1964 Corvette: Chevrolet Product Engineering Technical Information: Increased Capacity Fuel Pump

Subject: Increased Capacity Fuel Pump

Model and Year: 1964 Corvette 365-375 HP Engine and/or Air
Conditioning

Bulletin Number: Page 2 - Section VIIm - Group 2

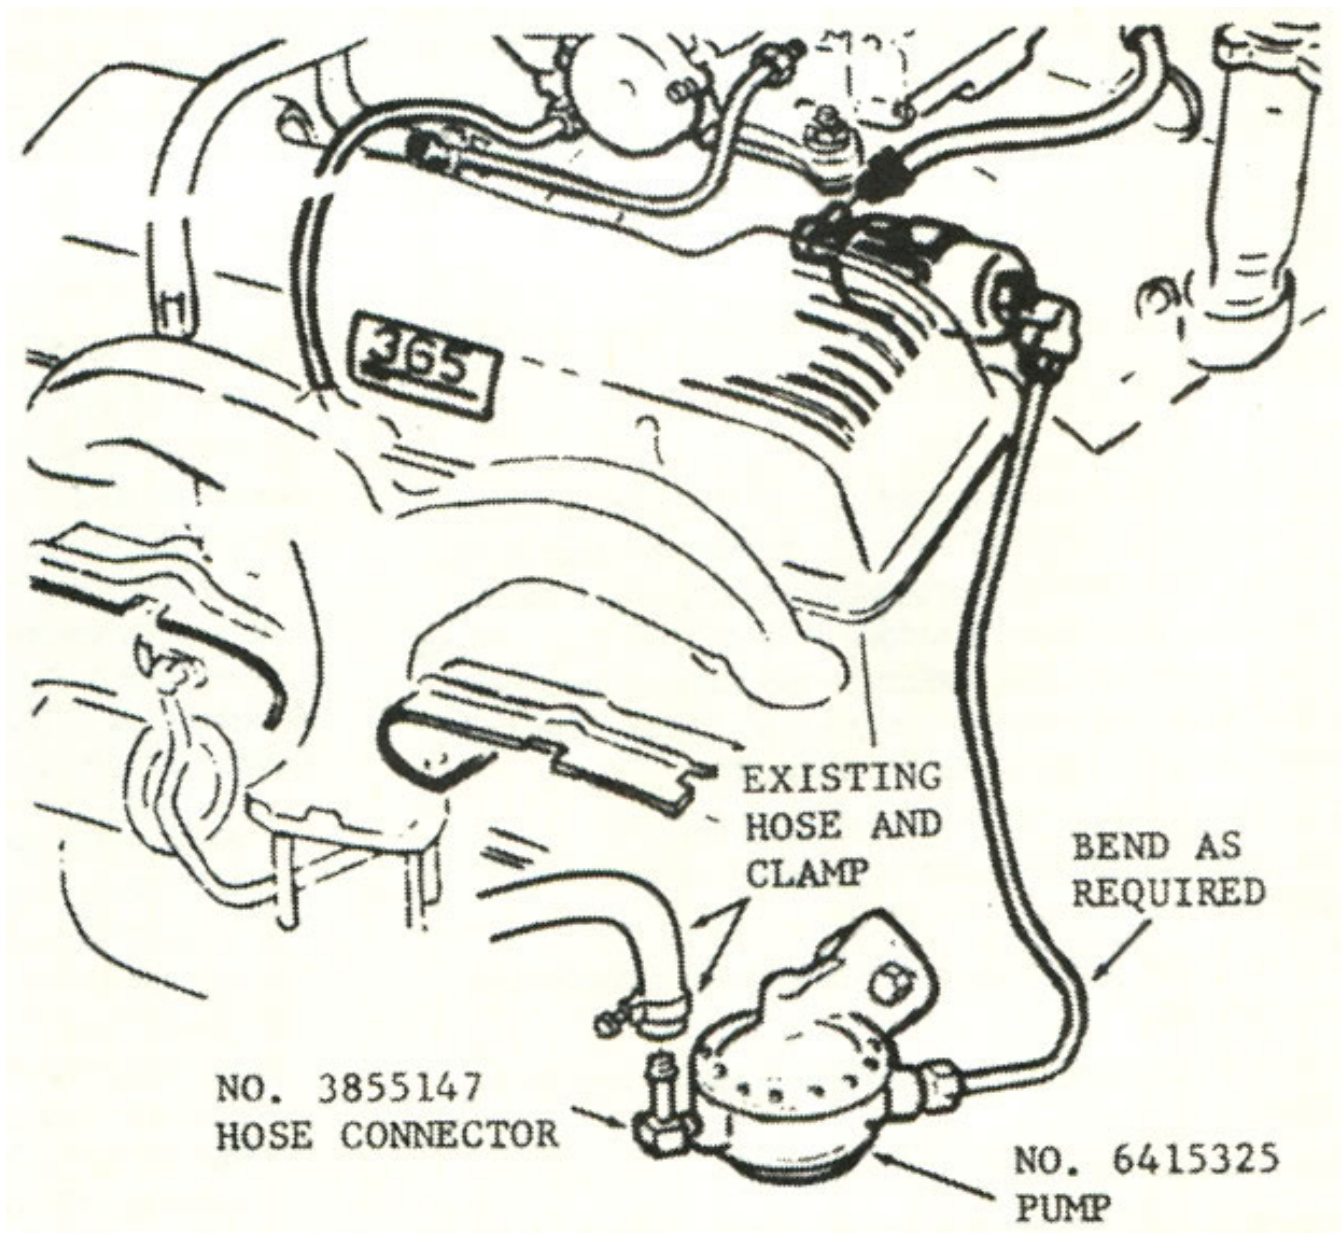
Corvettes with high performance engine options and/or air conditioning may experience a fuel vapor lock condition during high ambient temperatures. To eliminate this possibility, a new higher capacity fuel pump is used on late production units with the subject options. The new high capacity pump includes vapor bleed holes in the inlet and outlet valves.

To install the new design pump on early production Corvettes, replace the existing pump with part number 6415325 Pump and part number 3855147 hose connector elbow. Bend the existing gas line as required to match the outlet fitting.
